STAFF REPORT

SUBJECT: FP-2021-0058
Skybreak No. 1

Final plat consisting of 84 lots and 21 common lots on 35.67 acres of land in the R-8 and R-15 zoning districts.

C. Landscape Plan (date: 11/17/2021)

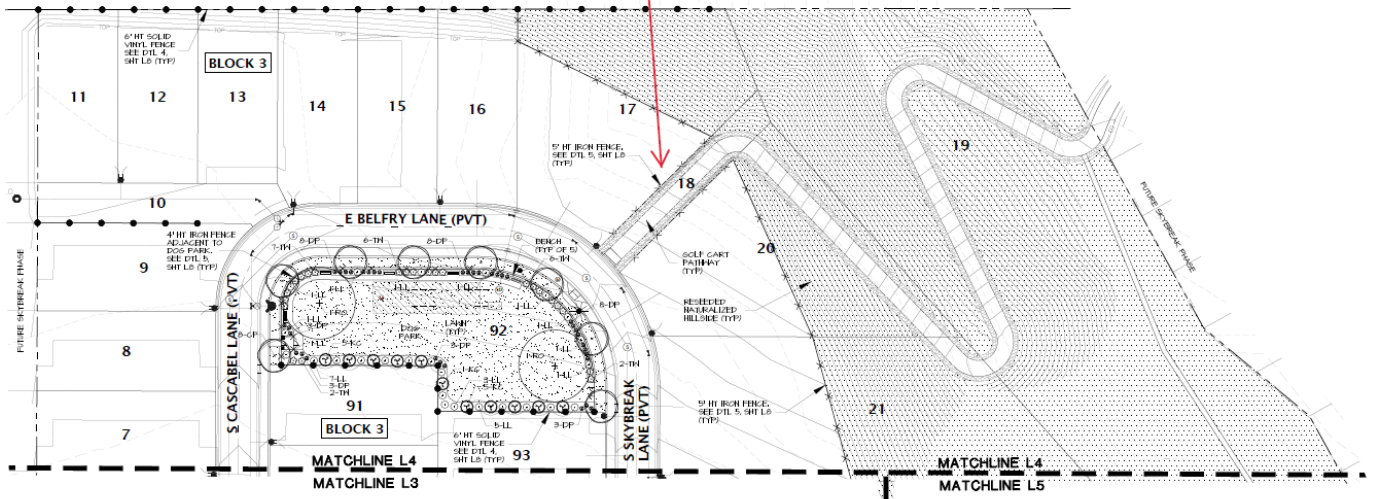
Staff notes although the applicant did receive alternative compliance from UDC 11-3B-12 and UDC 11-3G-3 to allow the area surrounding the pathway along Lot 46, Block 5 to remain in a natural state (now indicated as Lot 19, Block 3), this was intended for the area surrounding the natural pathway shown bisecting Lot 19, Block 3 from north to south. This did not extend to the paved golf cart pathway shown in both Lot 18 and 19, Block 3, as the approved preliminary plat landscape plan does show trees along this pathway. Also, the approved preliminary plat and landscape plan indicates sidewalk extending south along Lot 46, Block 3 to the Vantage Pointe subdivision, whereas this is absent on the final plat. Finally, the common drive exhibit indicates a 5 ft. wide landscape strip adjacent to the solid fence as required per UDC11-6C-3C, but this landscape strip is not shown on the landscape plan.

- a. Sidewalk meeting the requirements of UDC 11-3A-17 shall be added within Lot 46, Block 3 as shown on the approved preliminary plat landscape plan.

- b. Trees meeting the requirements of UDC 11-3B-12 shall be provided along the golf cart path in Lots 18 and 19, Block 3 shown on the approved preliminary plat landscape plan.

- c. A landscape strip meeting the requirements of 11-6C-3D shall be provided on the south side of the common drive in Lot 10, Block 3.
 - d. The landscape plan shall indicate any existing trees on the subject property that are four-inch caliper or greater; or mitigate for the loss of such trees as set forth in UDC 11-3B-10C.

Approved landscape plan shows trees along this pathway

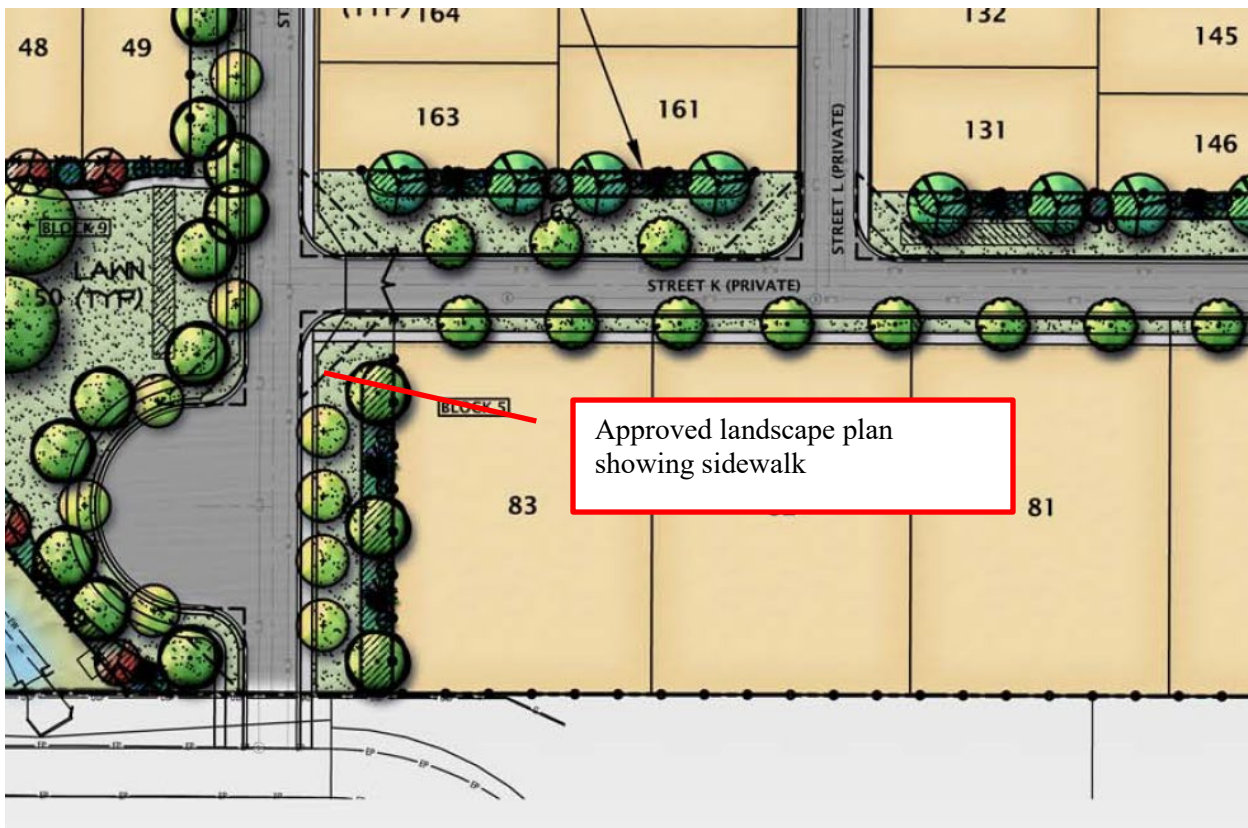
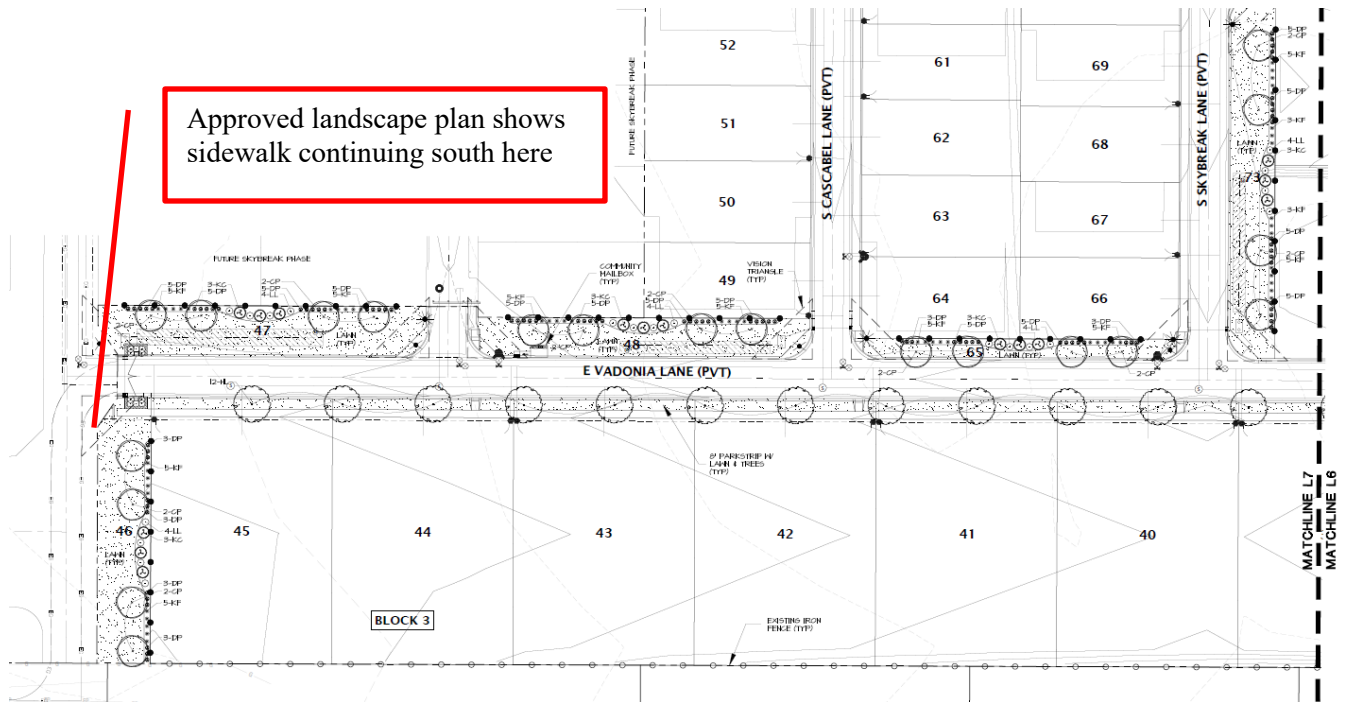
Same area from approved landscape plan
